SERVICE BULLETIN

M-993 MARCH 30, 1990

1990 SPORTSTER IGNITION WIRE REROUTING

Figure 1. Ignition Wire Routing

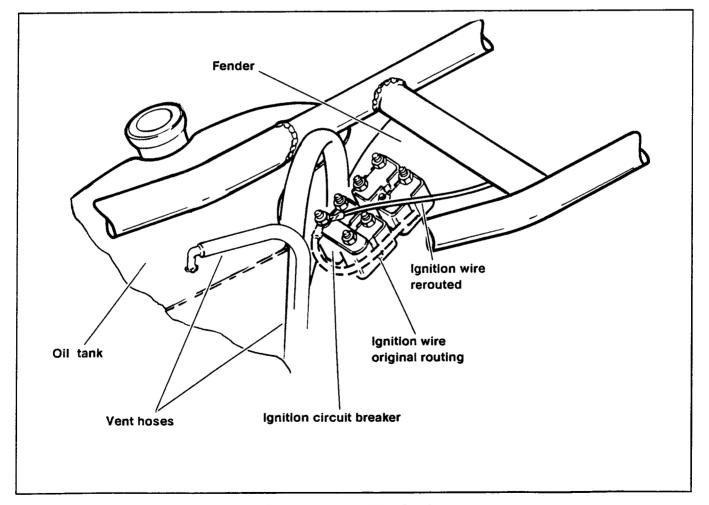
Beginning with the 1990 XL model year production, variations in assembly could cause contact between the white ignition wire and the oil tank and/or transmission vent hoses

See Figure 1. The white ignition wire is connected to the copper stud at the ignition circuit breaker, located on the vehicle rear fender. The ignition wire as originally routed is shown in dotted lines. The wire in this location could in some cases contact the vent hoses. Vent hose movement with normal engine vibration could cause the wire to break. Vehicles that have this condition could develop

erratic engine operation, misfiring, or loss of ignition spark.

In February, 1990, a change was made in production to eliminate the potential ignition wire contact problem. This condition is easily corrected by loosening the nut on the stud and rotating the wire terminal upward, away from the hoses. The wire is then routed between the circuit breaker studs as shown in solid lines. Tighten the nut. When ever you are servicing a 1990 Sportster vehicle please examine the ignition wire to be sure it is not close to the vent hoses. If a vehicle is at all suspect, reroute the wire as shown in figure 1.
